Preliminary Drainage Report
JeniShay Farms
Colorado Springs, Colorado 80908

Prepared for:
El Paso County, CO

February 25, 2021
PCD File #: SP209

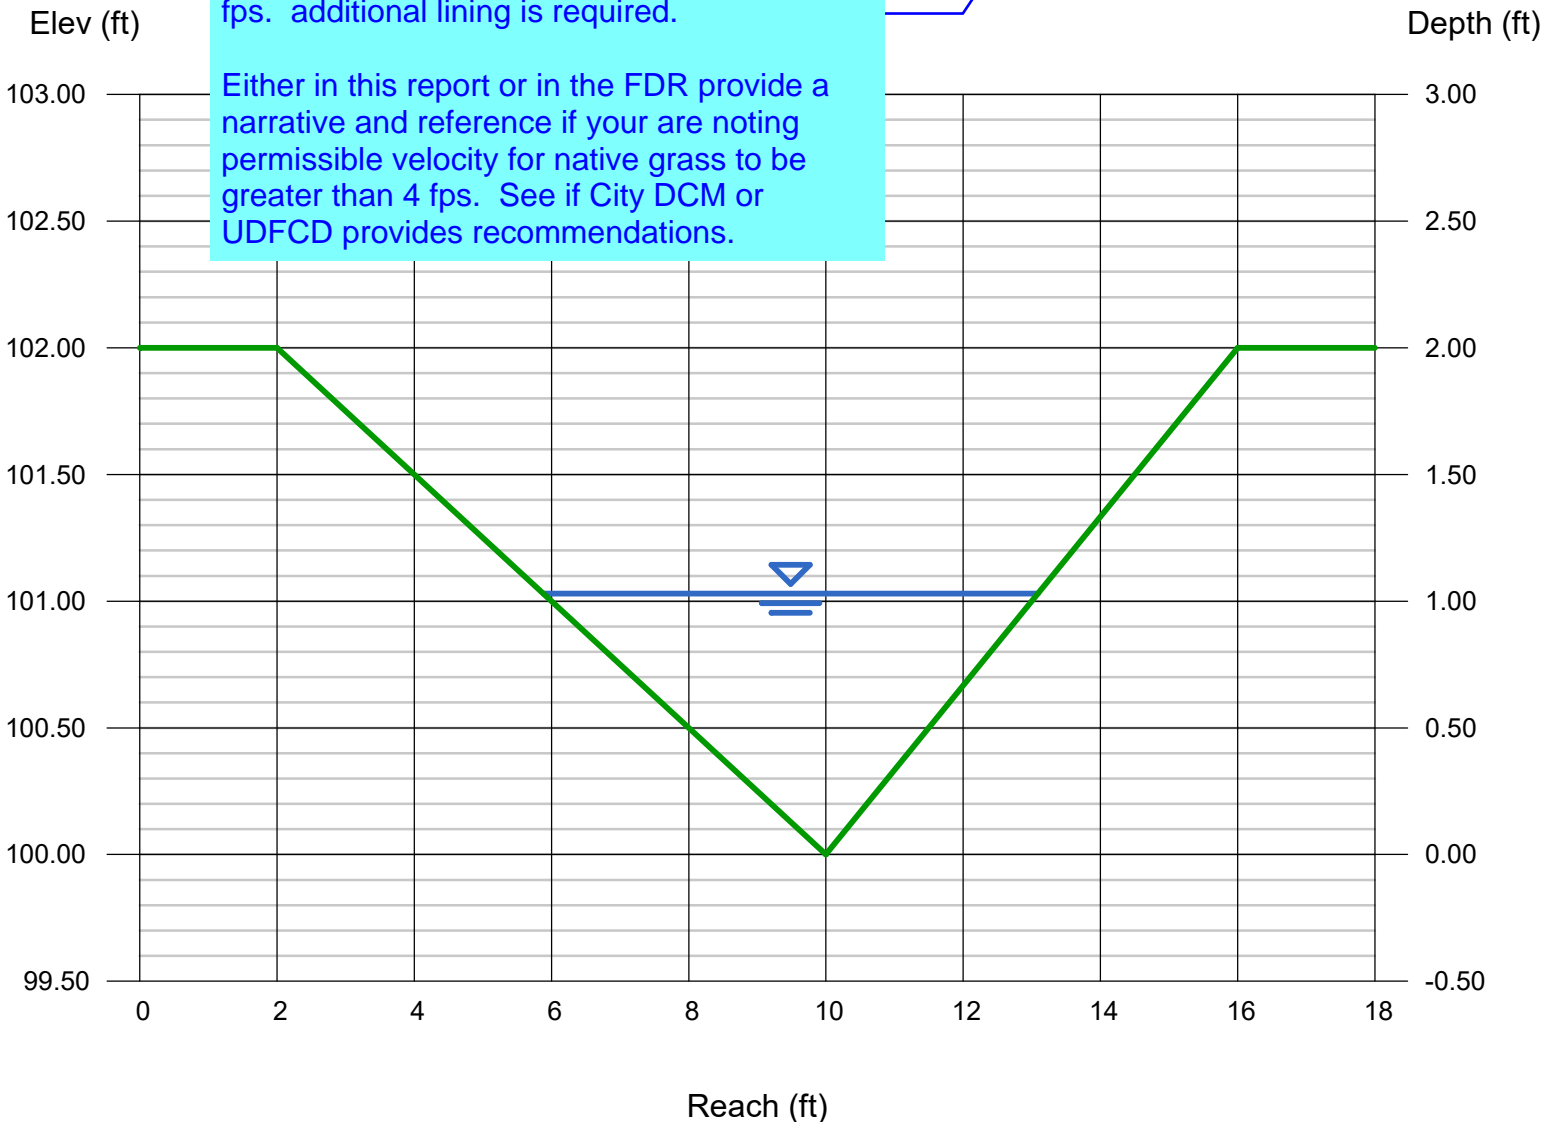
The 4.44 exceeds short native grass which typically have allowable velocities of 3 to 4 fps. additional lining is required.

Either in this report or in the FDR provide a narrative and reference if your are noting permissible velocity for native grass to be greater than 4 fps. See if City DCM or UDFCD provides recommendations.

ON-SITE BASINS
1"=100'

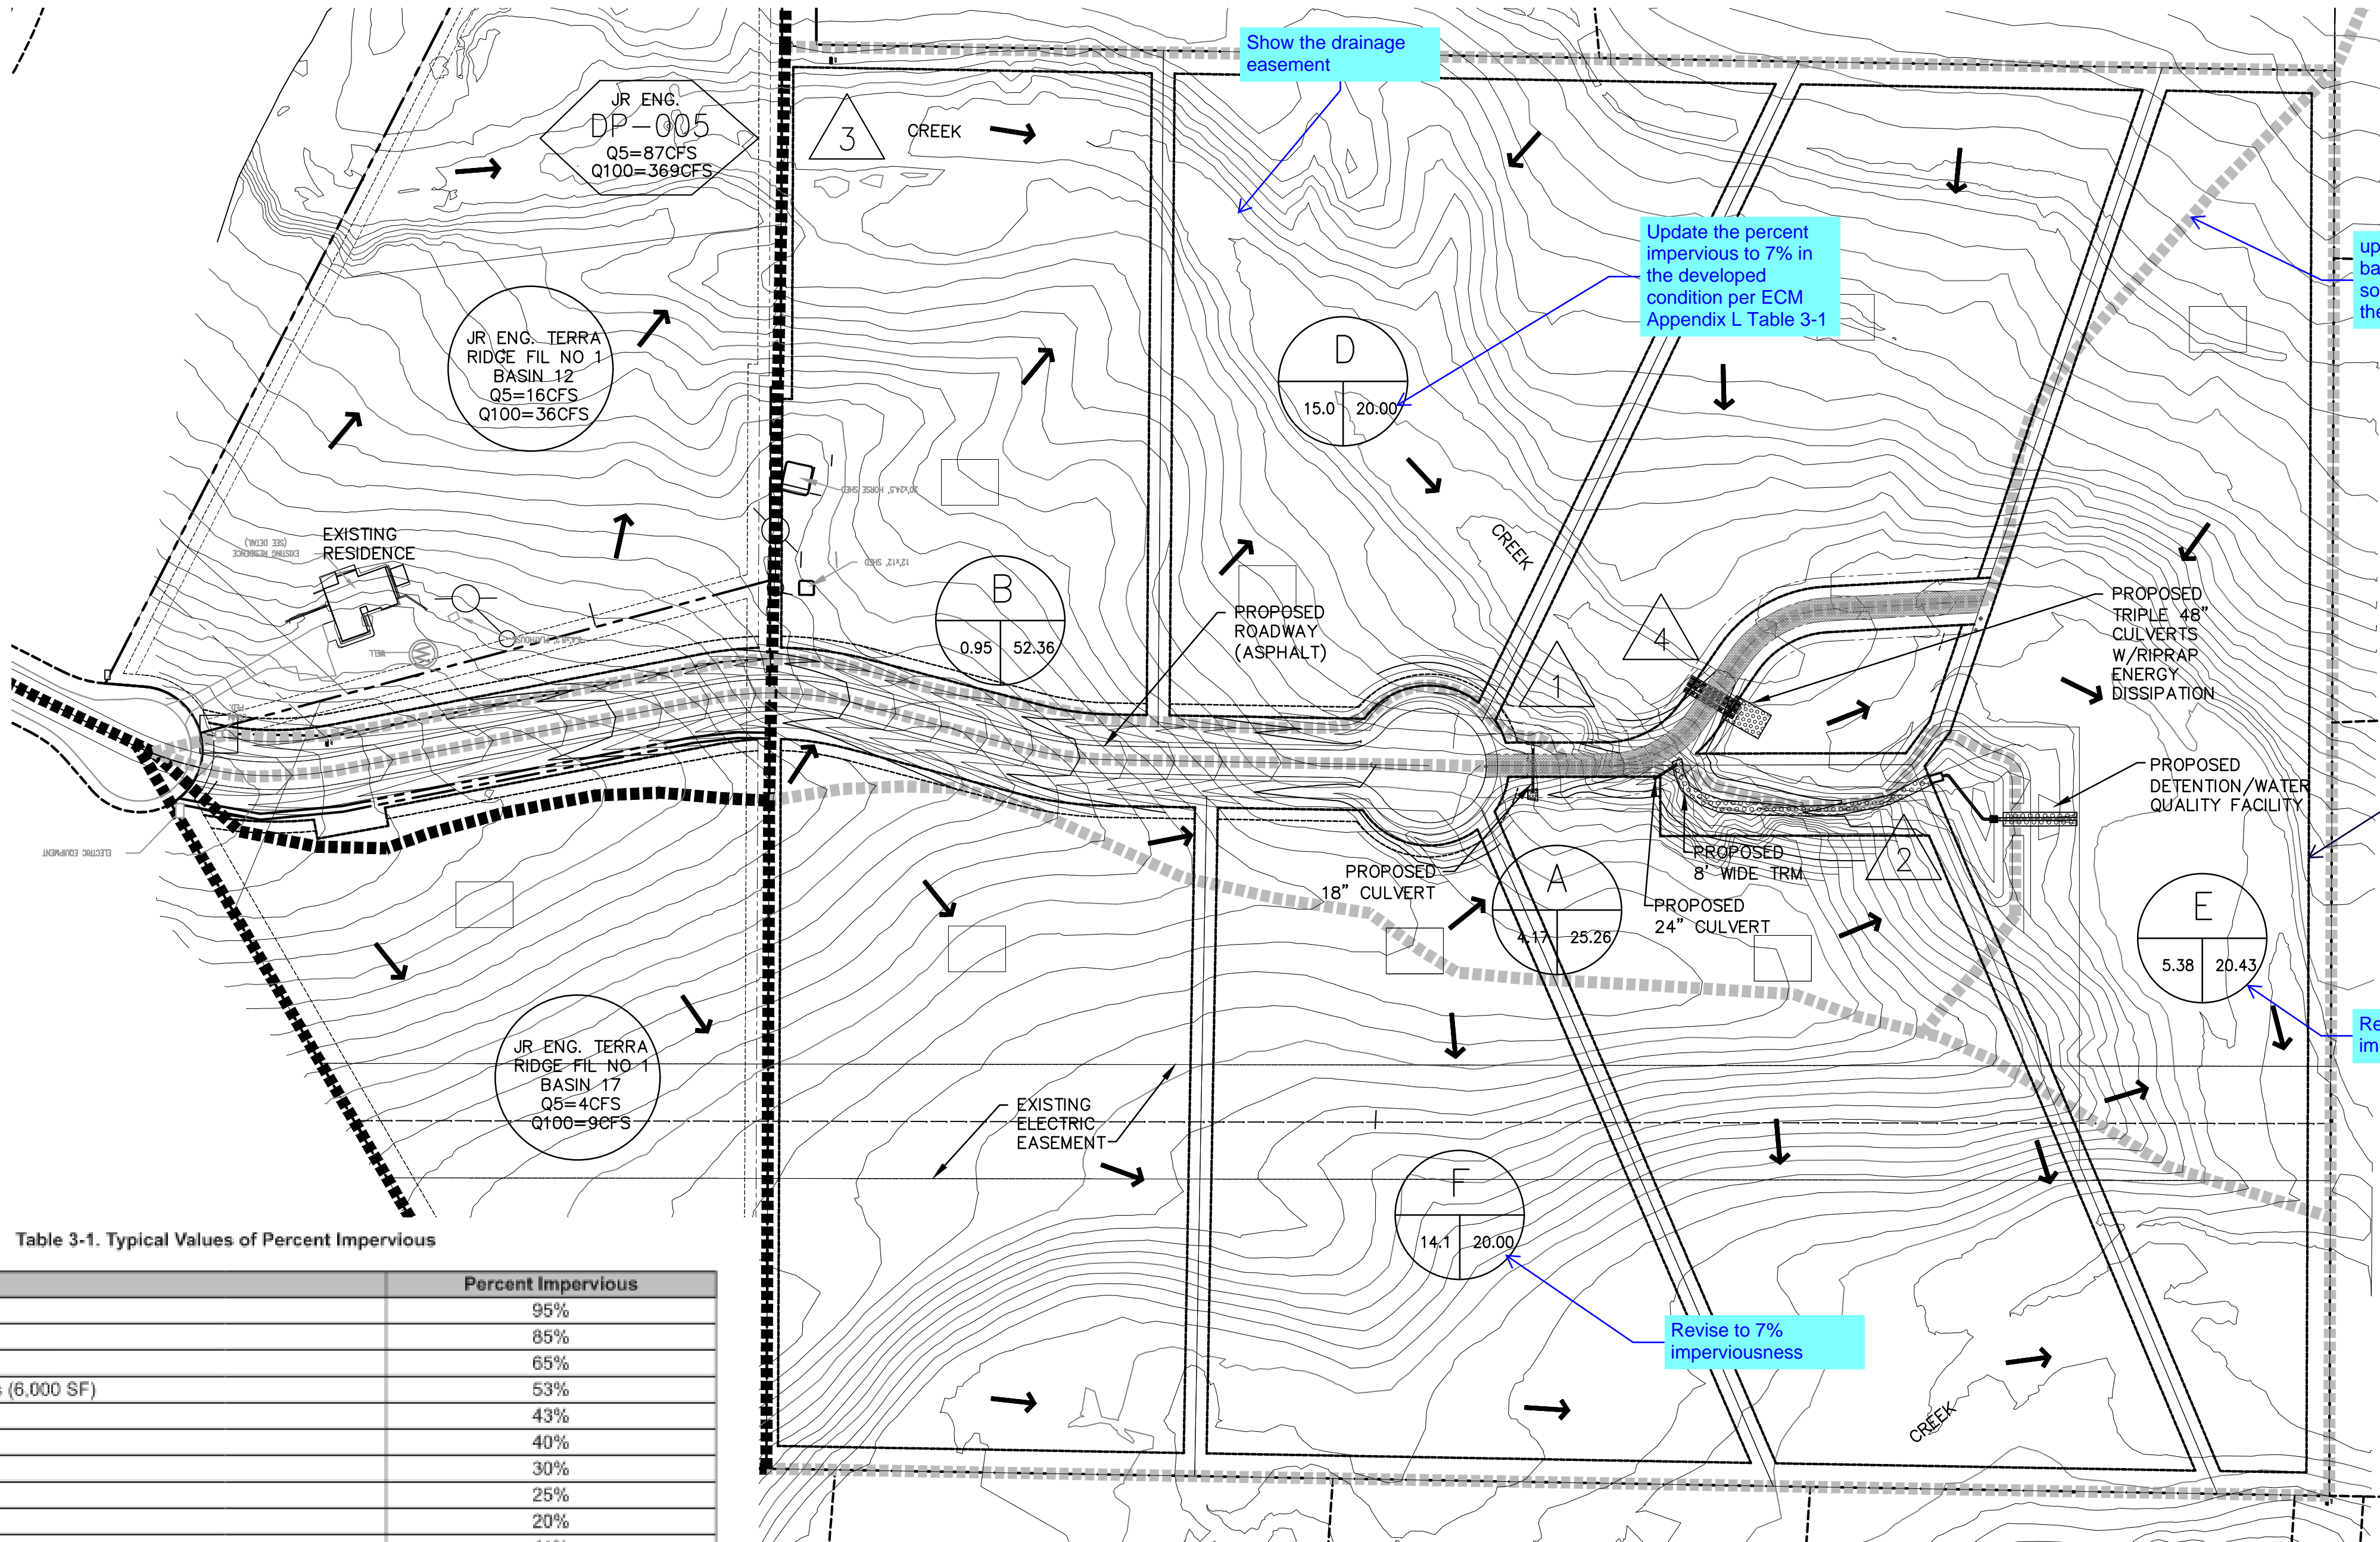
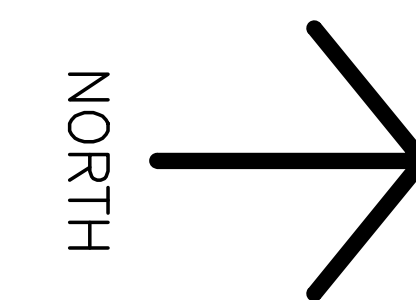
Fix existing contour line type to match the legend.

DRAINAGE PLAN

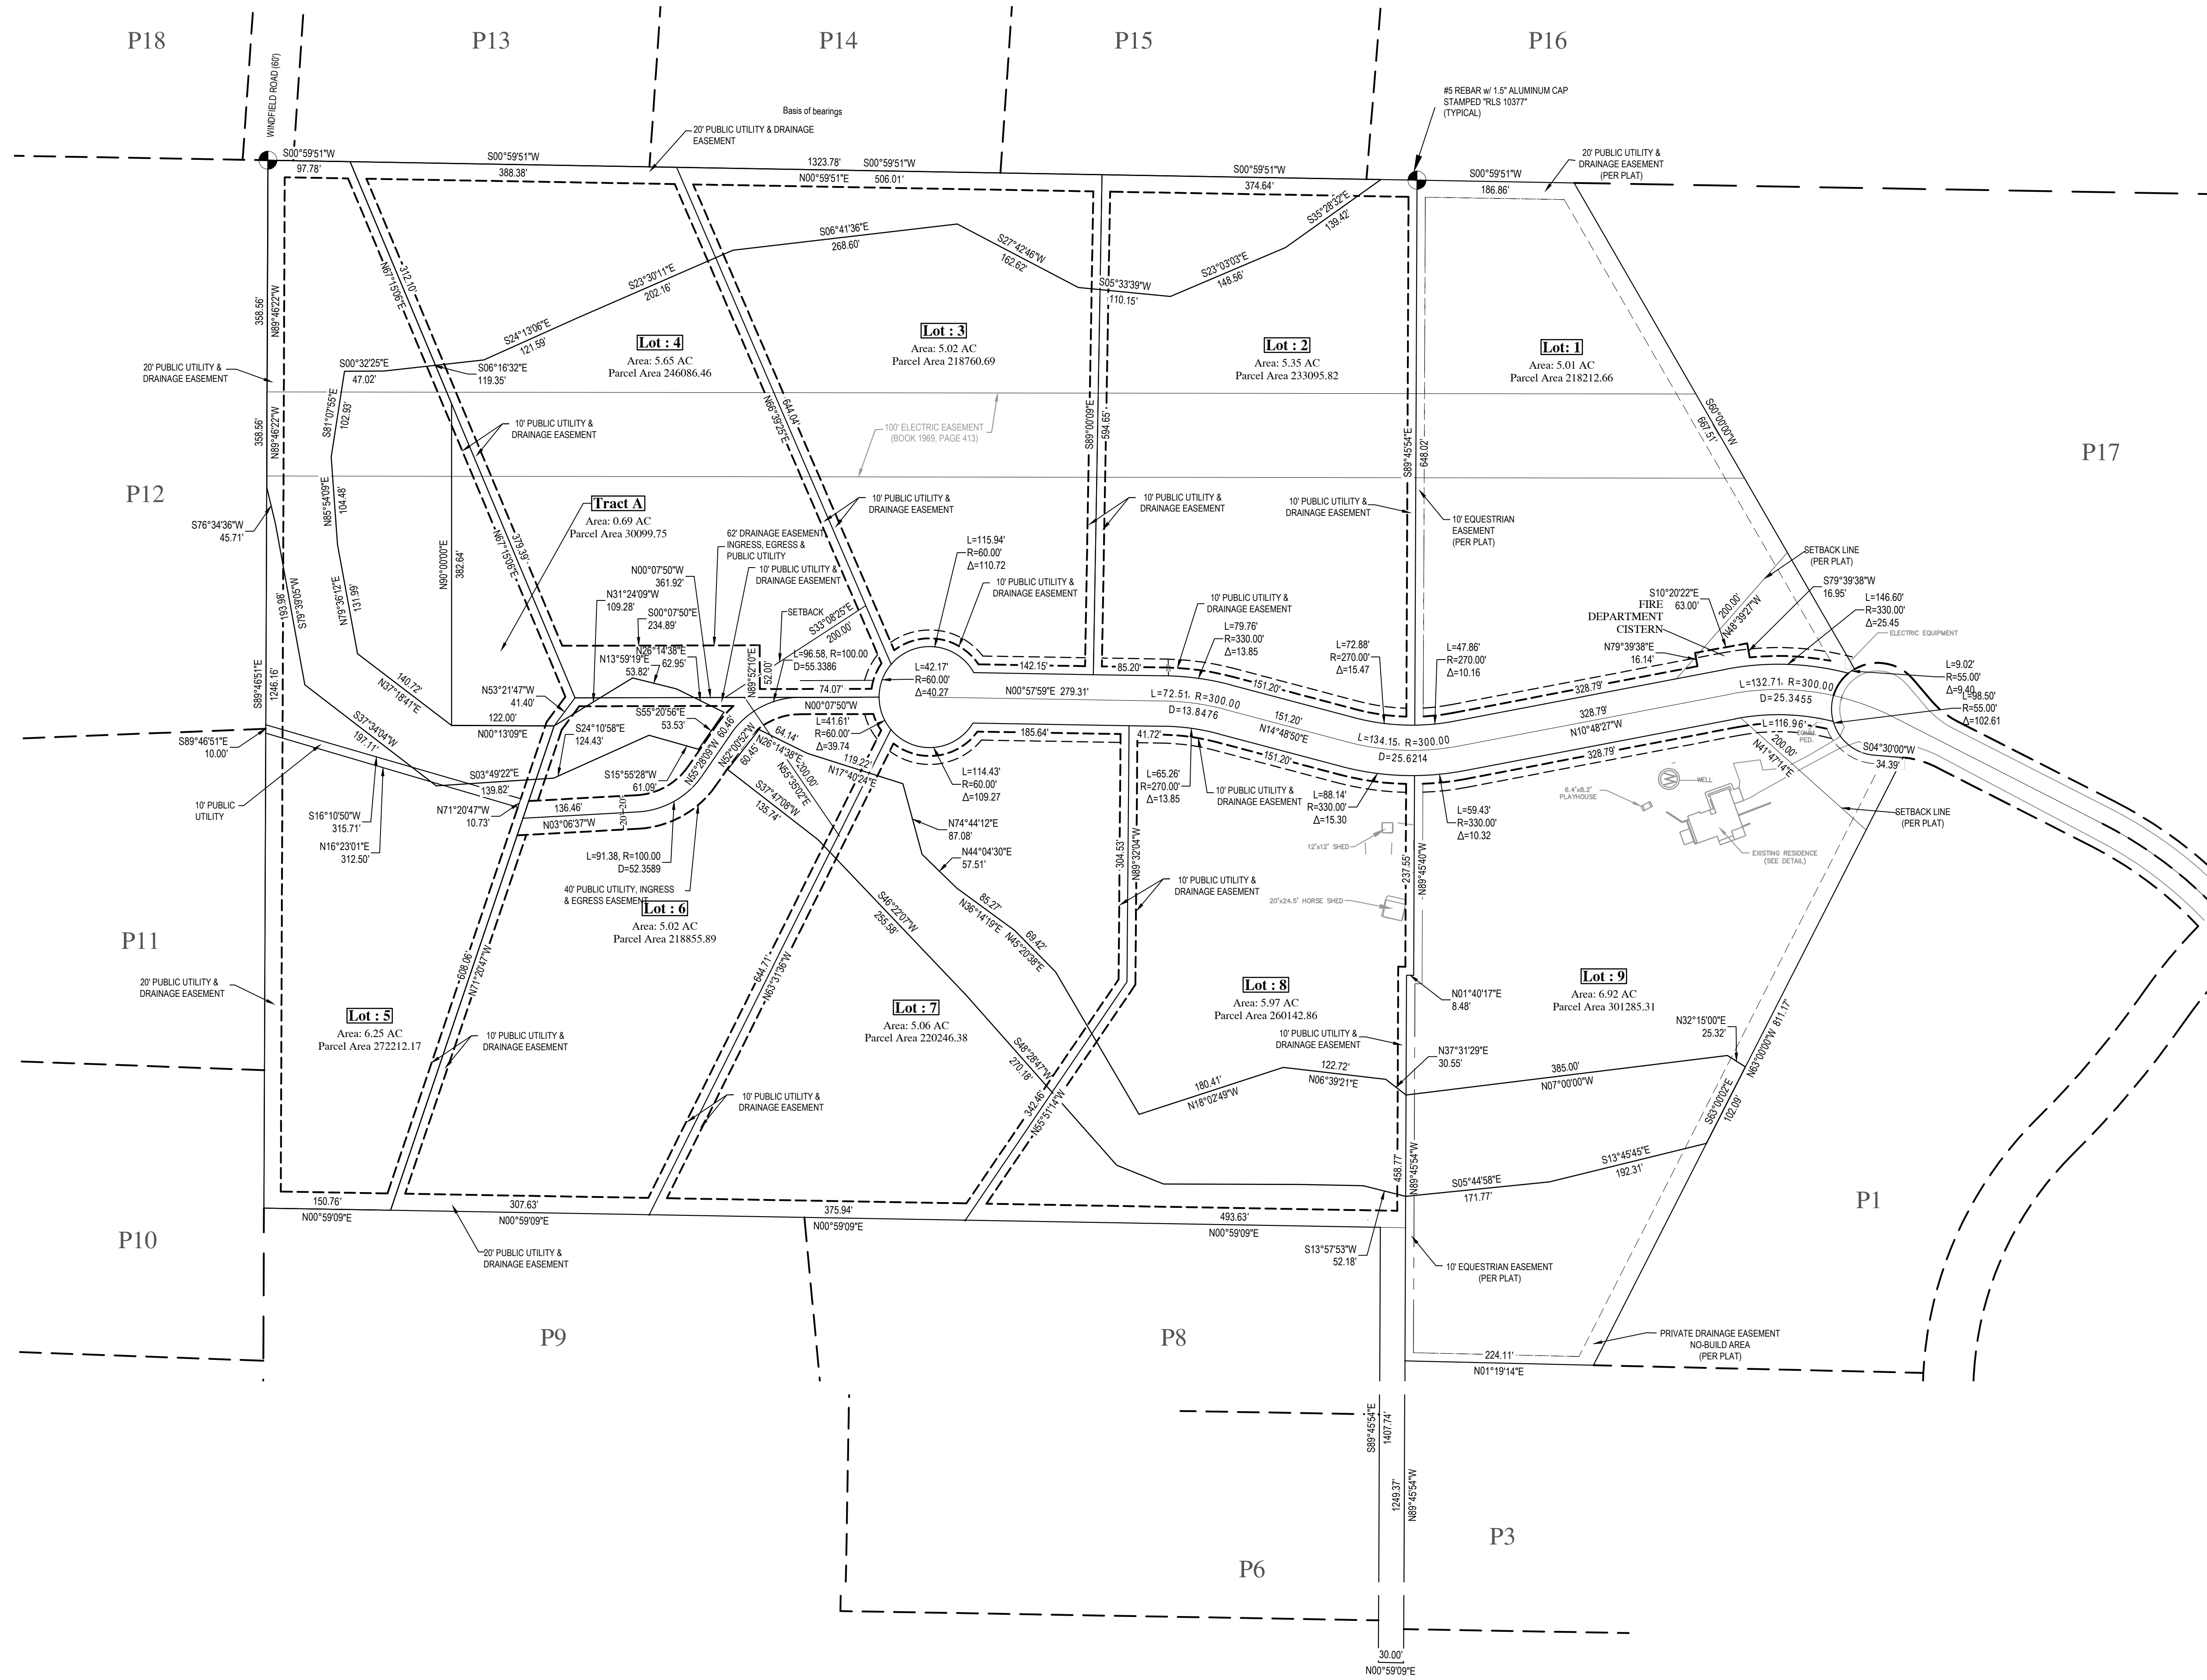
Remove sheet
